Access Compliance Report

(Curb Ramps)

Intersection ID: 52919	Main Street: HOOVER_CREEK_BV	Cross Street: WALKER_BRANCH_DR	Location: SW
ADA ID: F69C0AC52D62	Ramp Type: PerpDiag	Initial Pass/Fail: Fail	Overall Compliance: No
Severity Score: 13.75			
Codes/Mitigation Info/Possible Solution		Field Measurements/Component Compliance

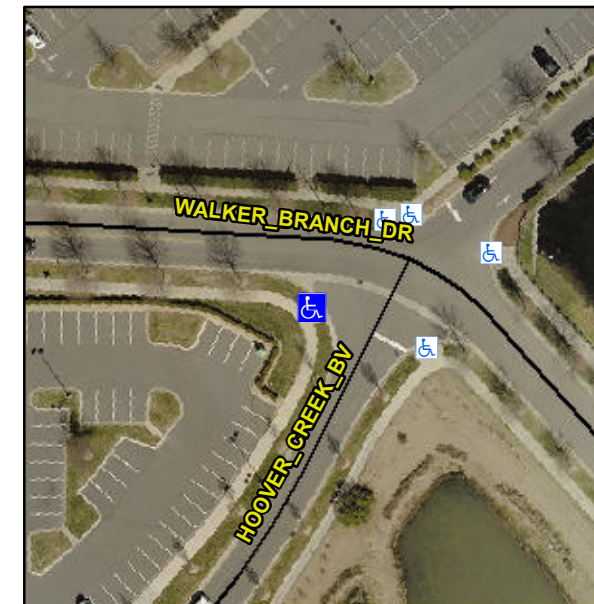
Not Found, R304.2.2, R304.5.3

Compliance	Description	Data	Compliance	Description	Data
N/A	Ramp Length (in)	86.0	No	Ramp Slope (%)	9.5
Yes	Ramp Width (in)	48.0	No	Ramp XSlope (%)	3.9
N/A	Flare Type LT	N/A	N/A	Flare Type RT	N/A
N/A	Flare Slope LT (%)	N/A	N/A	Flare Slope RT (%)	N/A
N/A	Flare Traversable LT?	N/A	N/A	Flare Traversable RT?	N/A
N/A	Landing Length (in)	N/A	N/A	DWS Provided?	N/A
N/A	Landing Width (in)	N/A	N/A	DWS Contrast?	N/A
N/A	Landing Slope (%)	N/A	N/A	DWS Length (in)	N/A
N/A	Landing X Slope (%)	N/A	N/A	DWS Full Width?	N/A
N/A	Landing Curb? (Y/N)	N/A	N/A	DWS Offset (in)	N/A
N/A	Shared Landing?	N/A			
N/A	Gutter Ponding?	N/A	N/A	Gutter Slope (%)	N/A
N/A	Gutter Lip Ht (in)	N/A	N/A	Gutter X Slope (%)	N/A
N/A	Painted X Walk1?	No	N/A	Painted X Walk2?	No
	X Walk 1 Direction	To SE		X Walk 2 Direction	To NE
N/A	X Walk 1 Width (in)	N/A	N/A	X Walk 2 Width (in)	N/A
	X Walk 1 Slope (%)	2.9		X Walk 2 Slope (%)	1.9
	X Walk 1 X Slope (%)	0.6		X Walk 2 X Slope (%)	3.0

Remove & Replace Curb Ramp With Two New Directional Ramps or Equivalent.
